BID Addendum-01

Project No.
JCDT23-0185

Title
Bid Clarification 01

Project Name
St Clair County Heath Dept Relocation

1 Fire Protection Plan - Floor 1 New Work
 F40-01 SCALE: 1/8" = 1'-0"

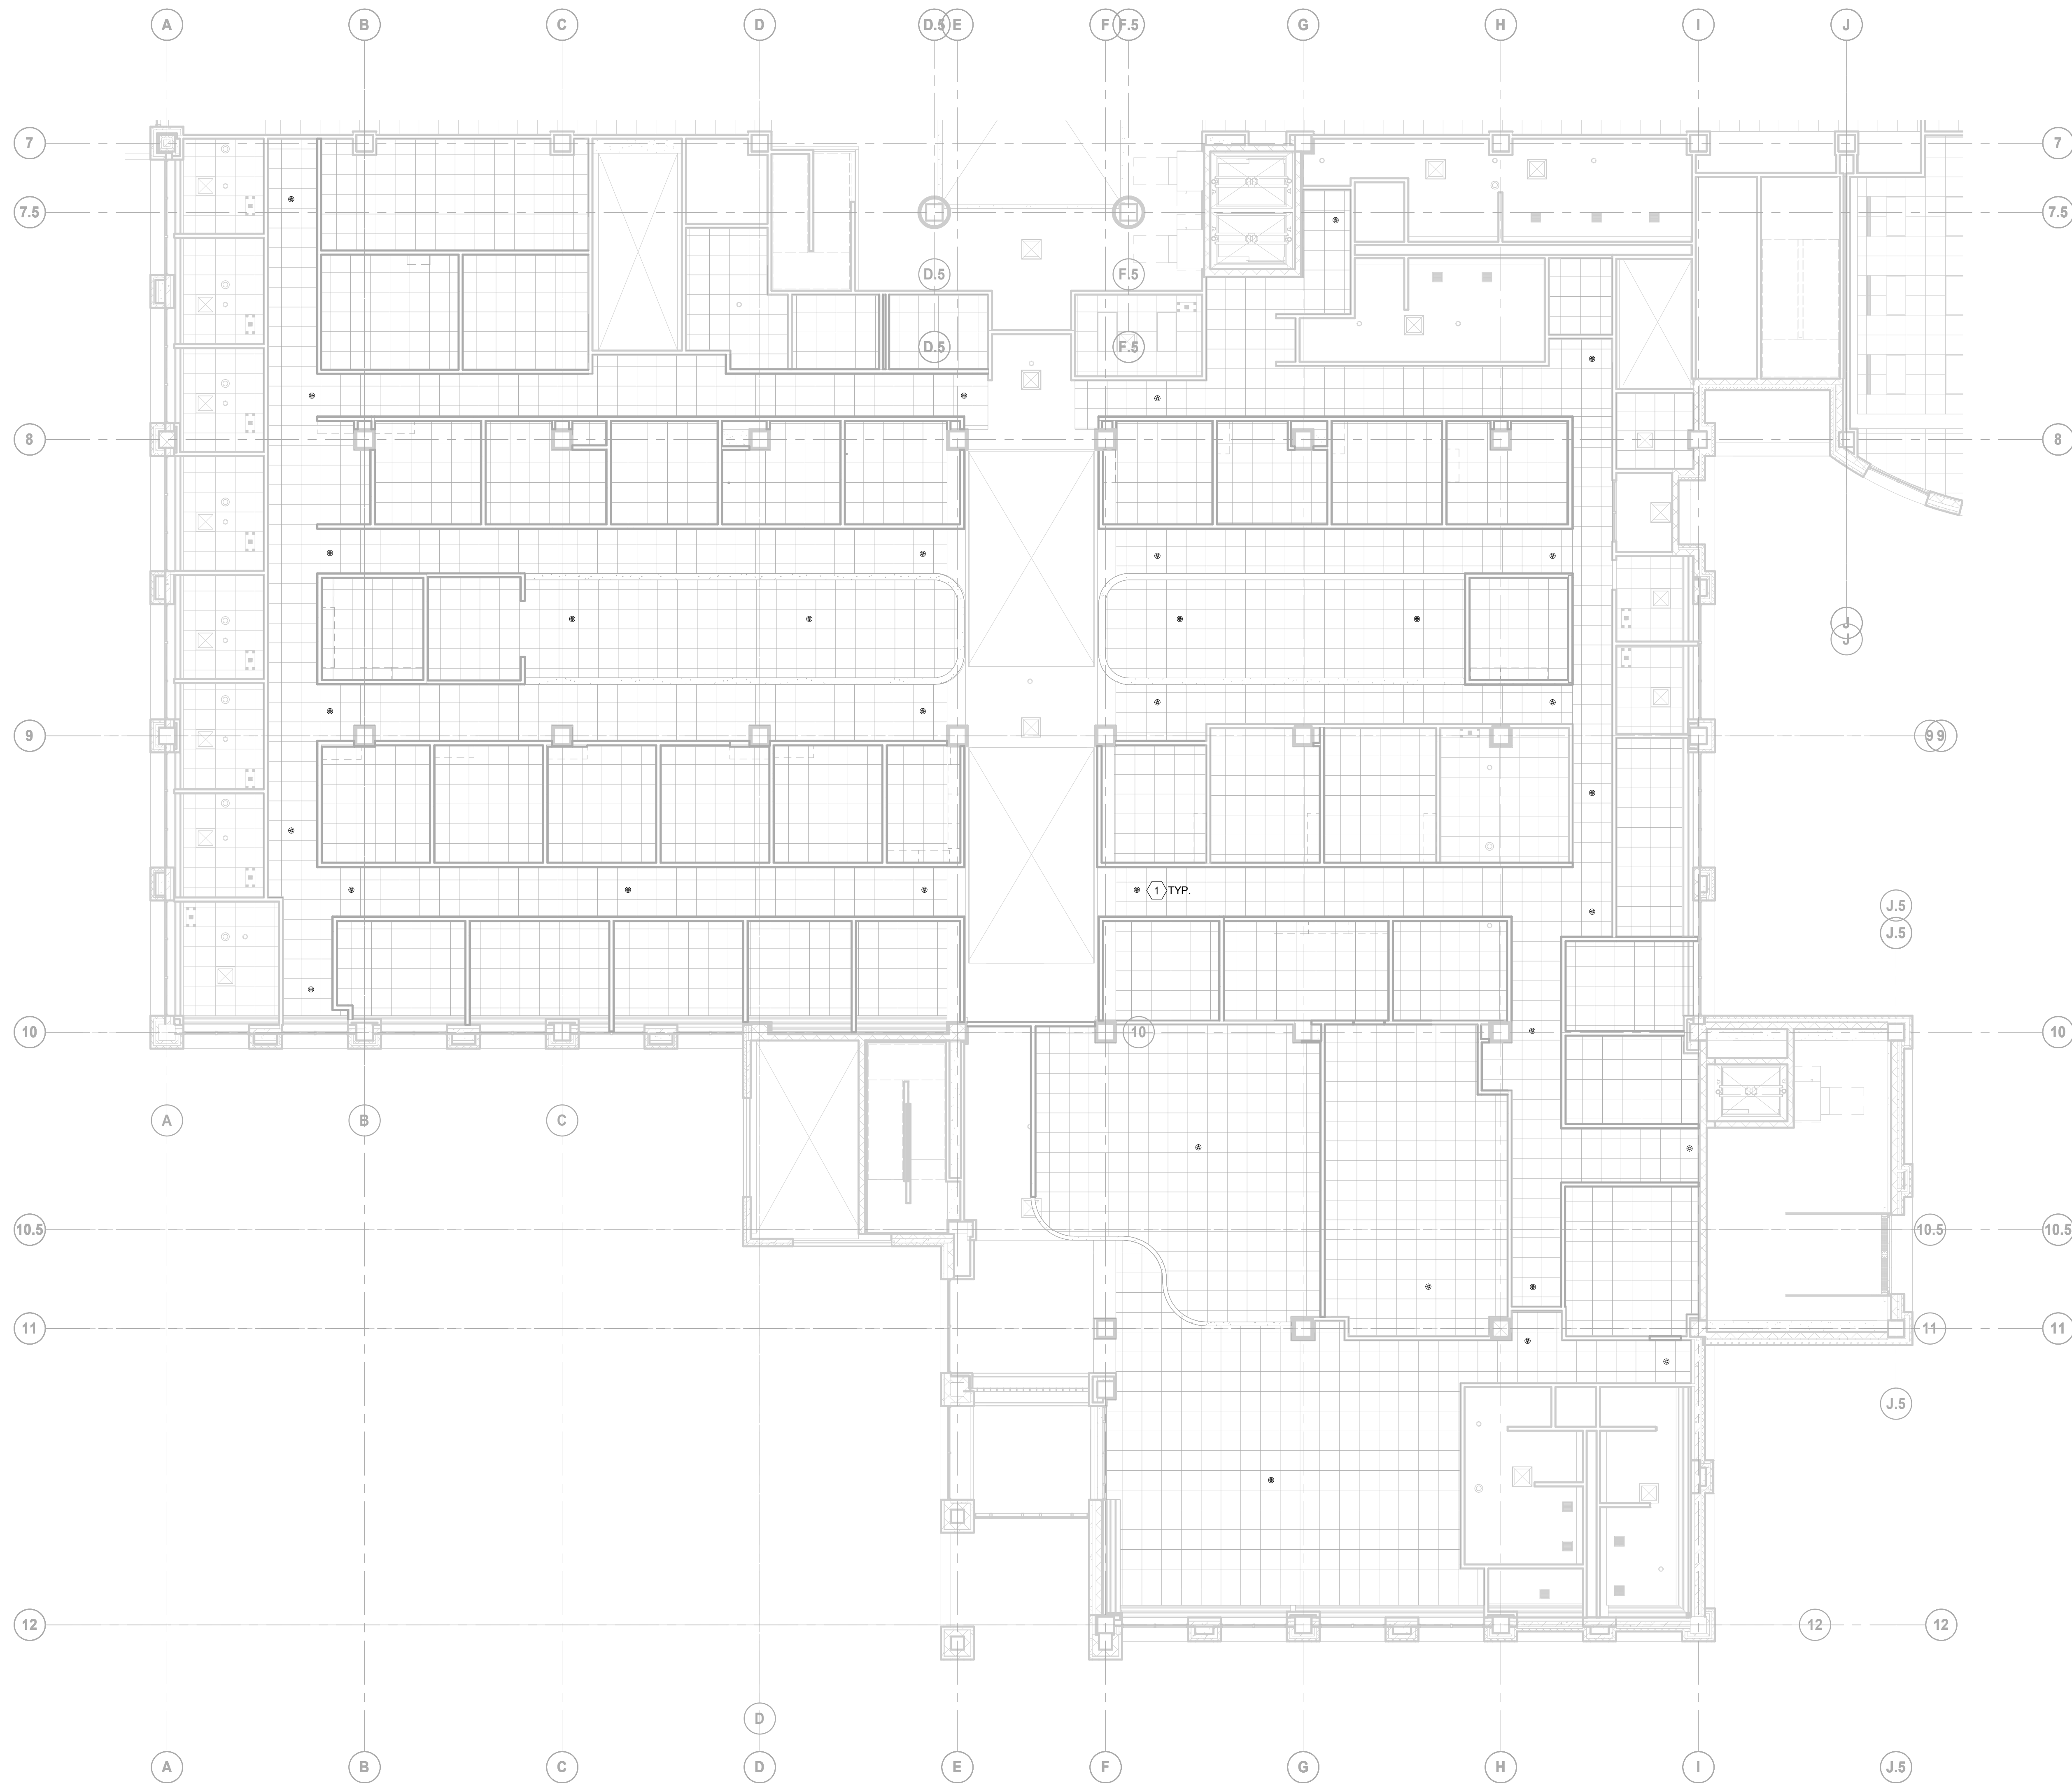
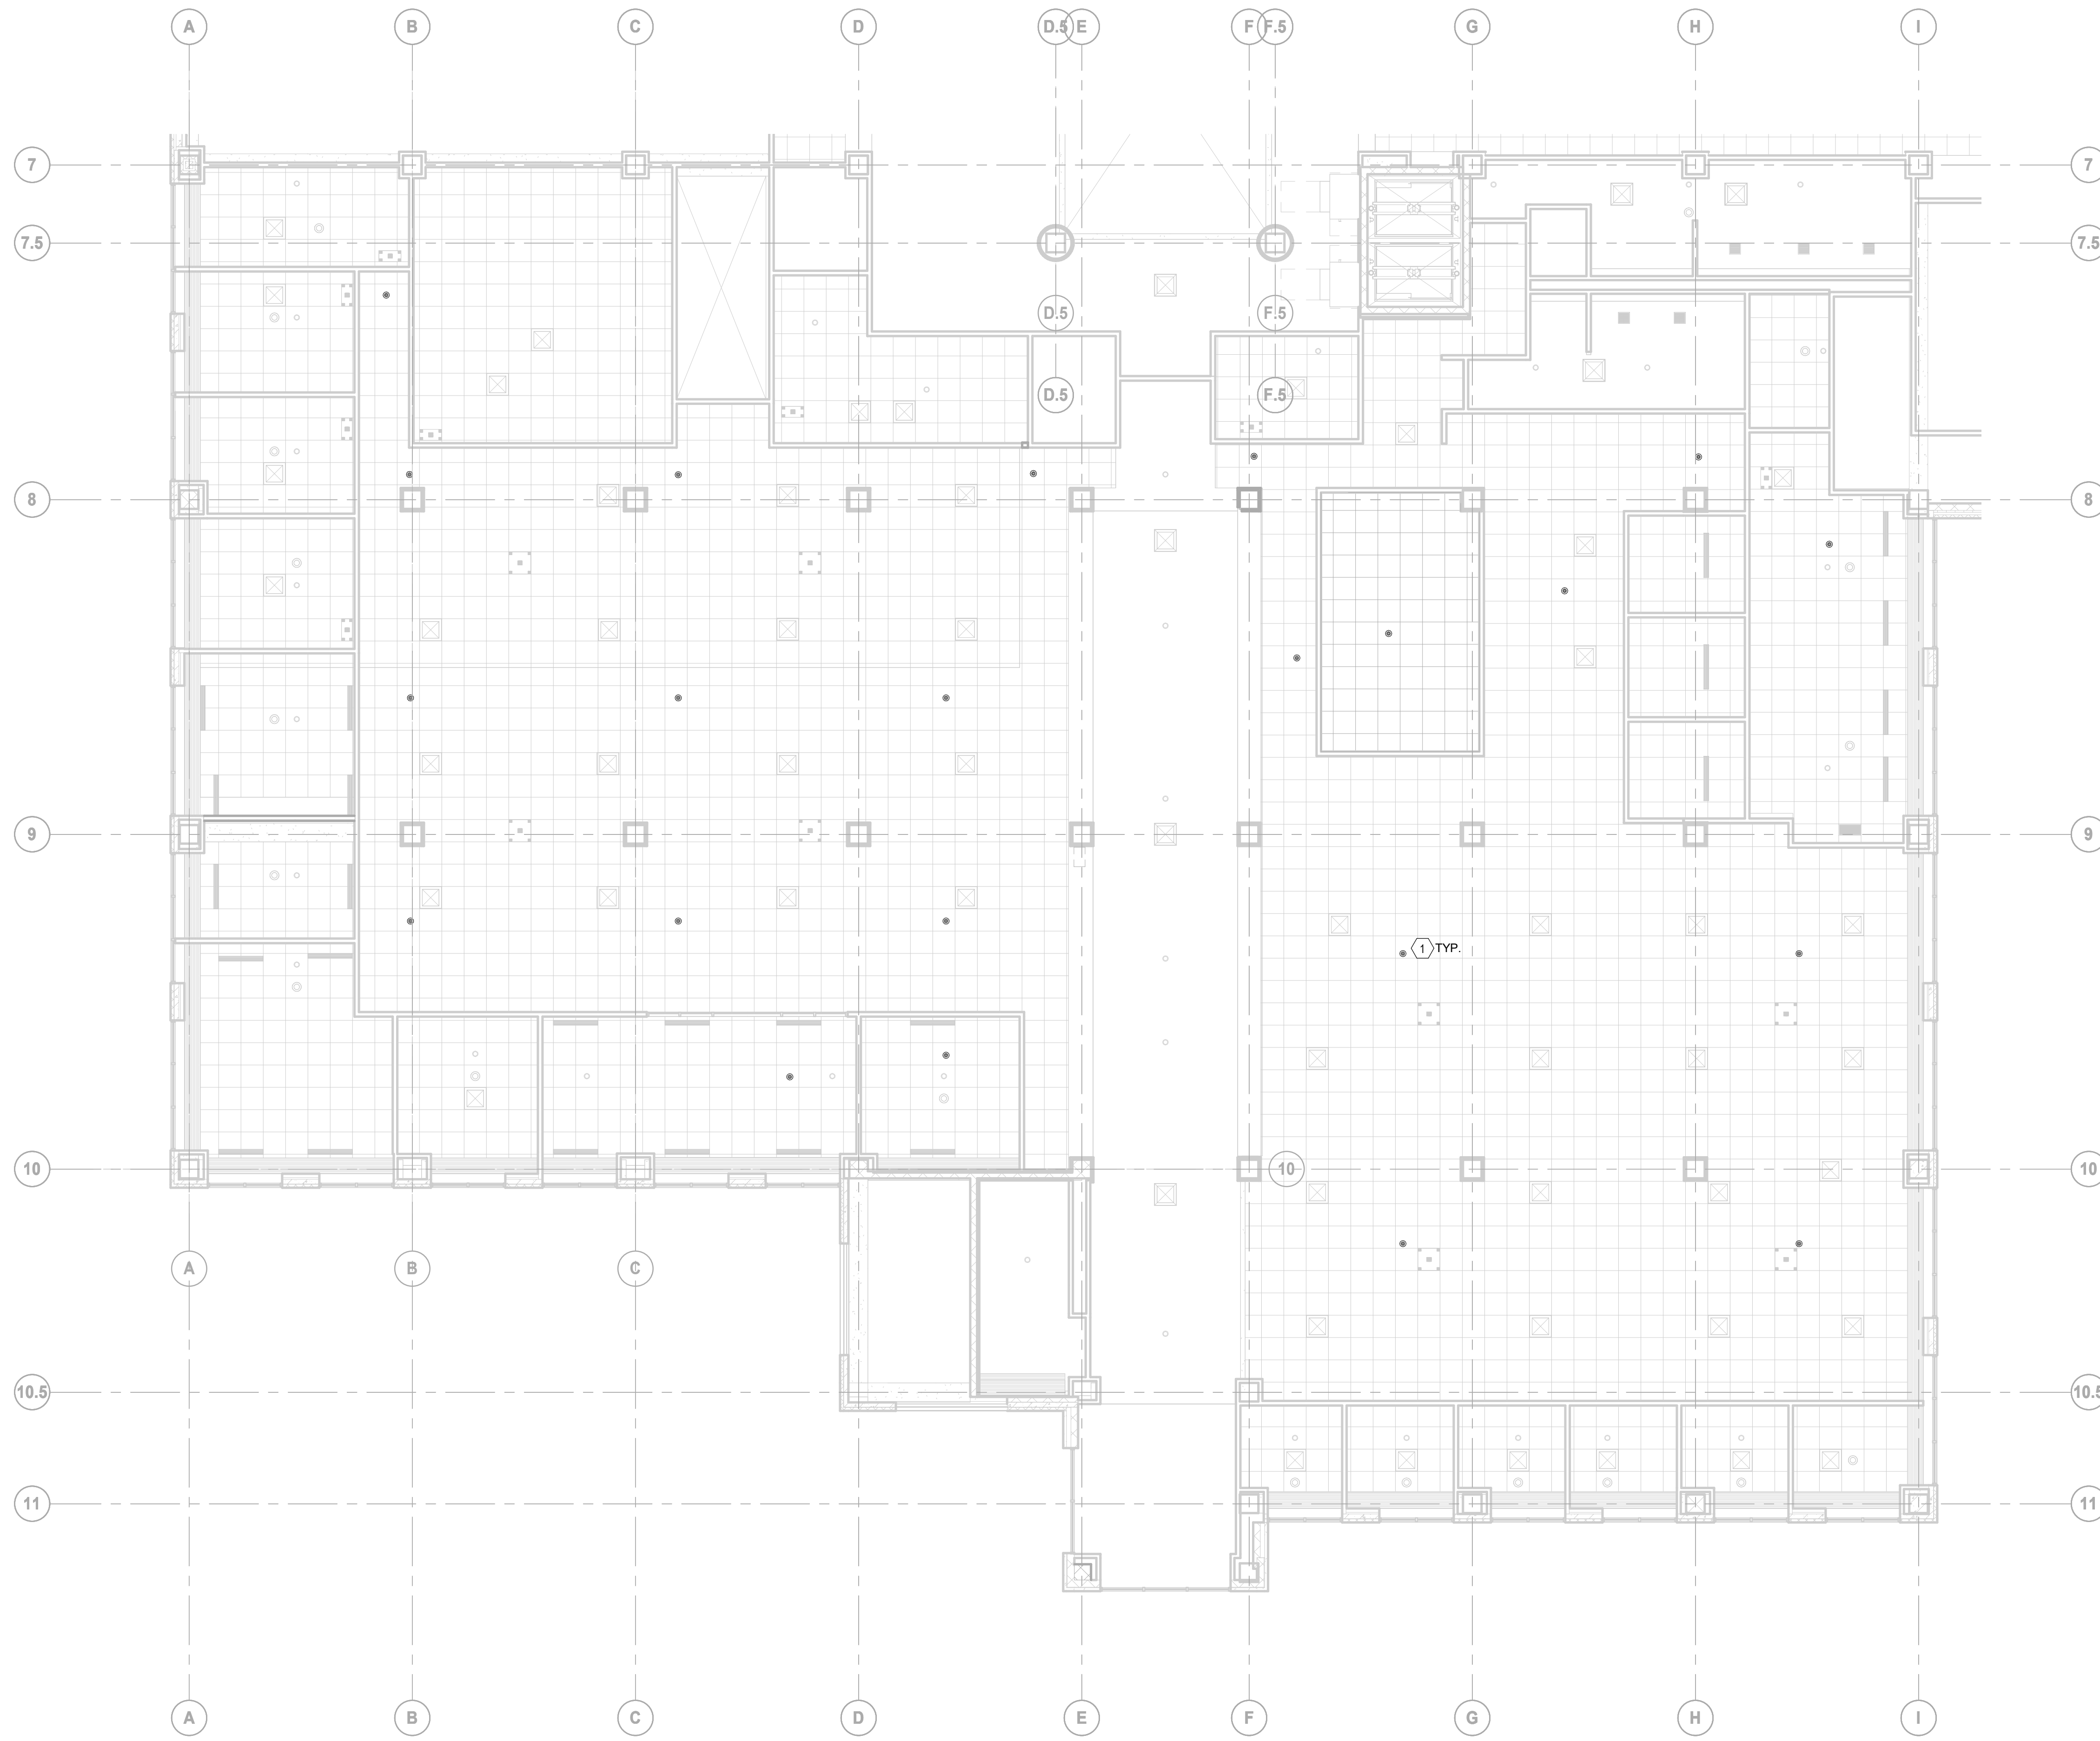
1. Dwg No F40-01
 - a. Added new sheet with fire protection new work scope.
2. Dwg No F40-02
 - a. Added new sheet with fire protection new work scope.
3. Dwg No F80-01
 - a. Added new sheet with fire protection demo scope.
4. Dwg No F80-02
 - a. Added new sheet with fire protection demo scope.
5. Dwg No M00-01
 - a. Added mechanical and plumbing symbol list.
 - b. Added sheet list.

7 HEAT PUMP/ DRAIN PAN DETAIL
SCALE: 1/8" = 1'-0"

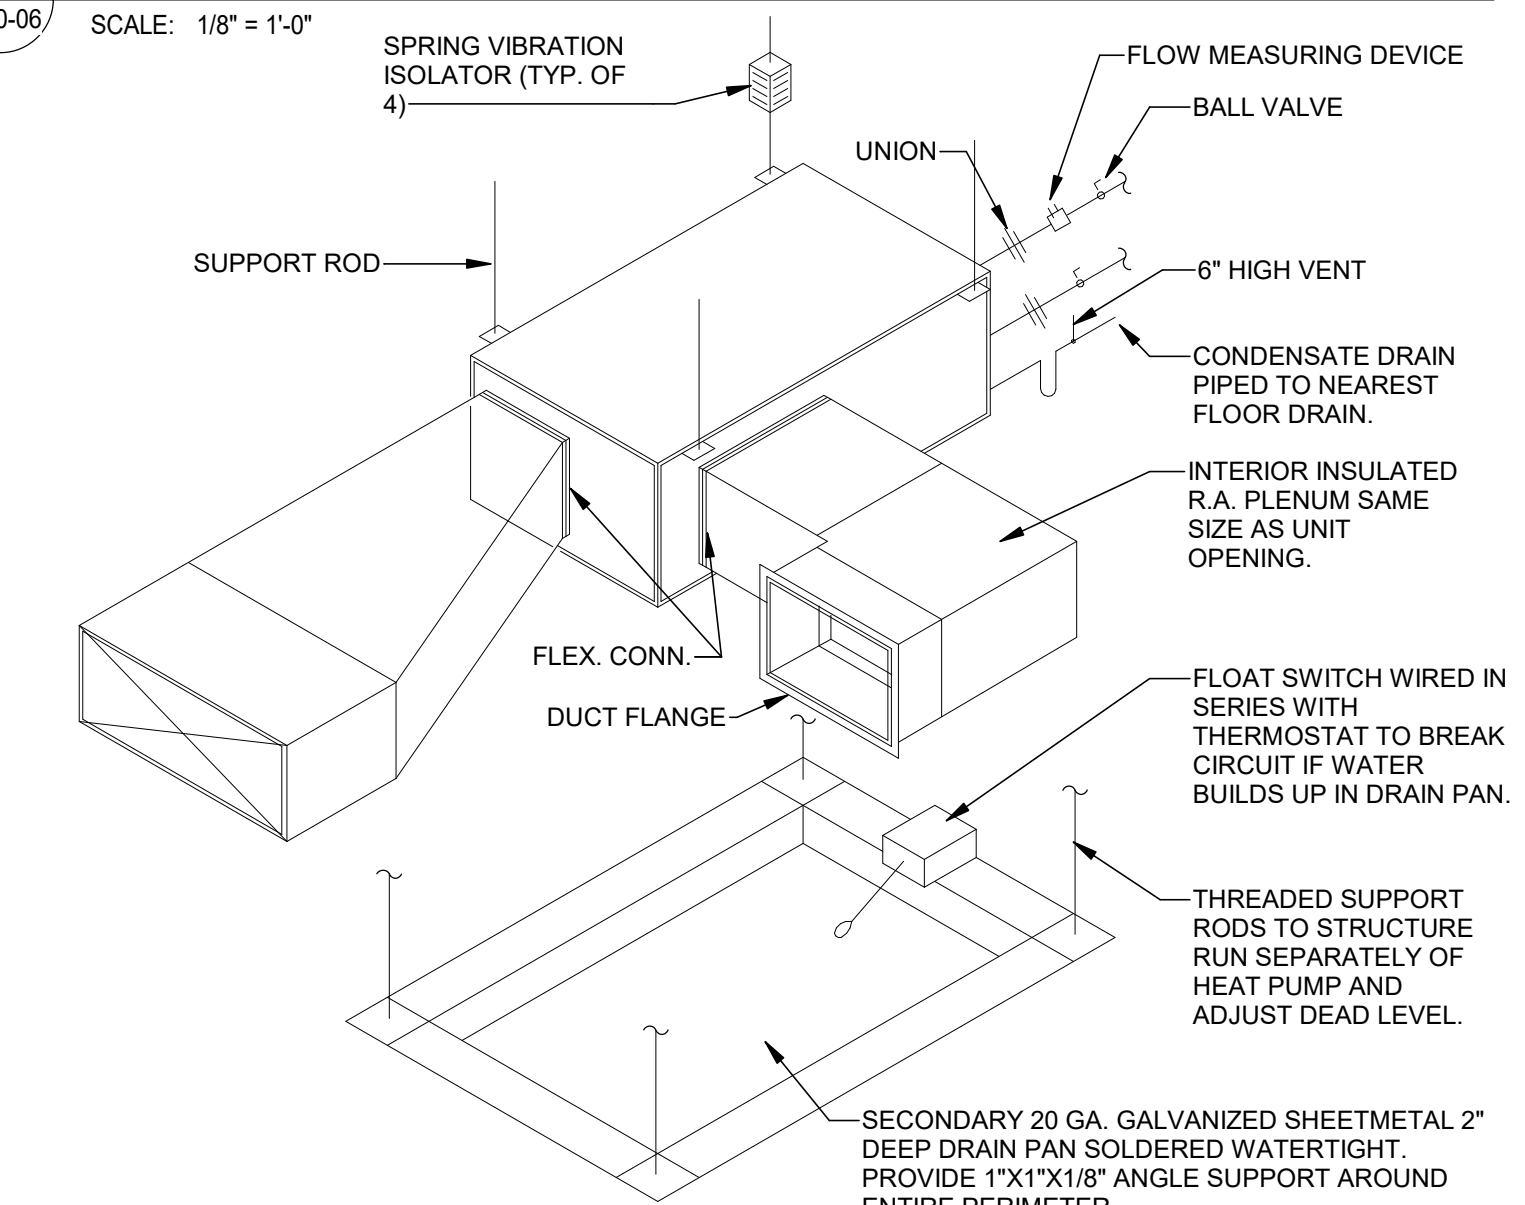
- a. Removed interior insulation from heat pump/ drain pan detail.
10. Dwg No M50-00
 - a. AHU-1 relocated within basement with hydronic piping routing revised.
